Project: Sanitation Programme :Nexus and Resources Protection Component
C5:Sewer Networks in Mansour ,Um Halilifa and Khirbt Musallam

Contract No : 36/2021/SW /KfW Tender No.505475 /BMZ No.201366848

Subject: Addendum NO.3

**Addendum No. 3 to Tender Documents for
“Sanitation Programme: Nexus and Resources Protection
Component C5: Sewer Networks in Mansour, Um Halilifa and Khirbet
Musallam”**

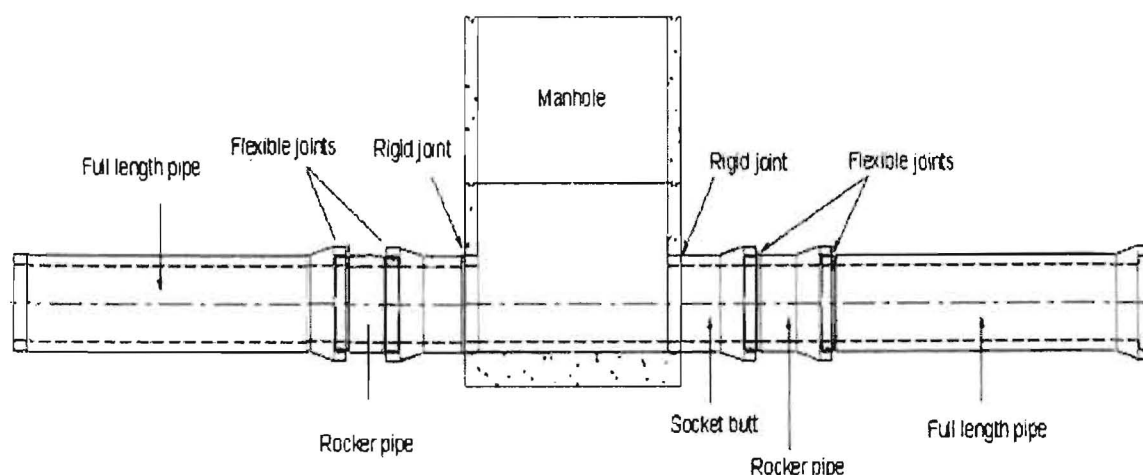
Question No. 05: Reference to Volume 3, drawing no. NEXUS-SB-SD-01 standard detailed typical manholes details kindly provide us wall thickness for precast manhole rings.

Answer No. 05: The wall thickness of the manholes ring shall be a minimum of 120 mm, this thickness shall however be verified by the successful bidder when submitting the reinforcement details. Refer to Note 16 on drawing no. NEXUS-SB-SD-01.
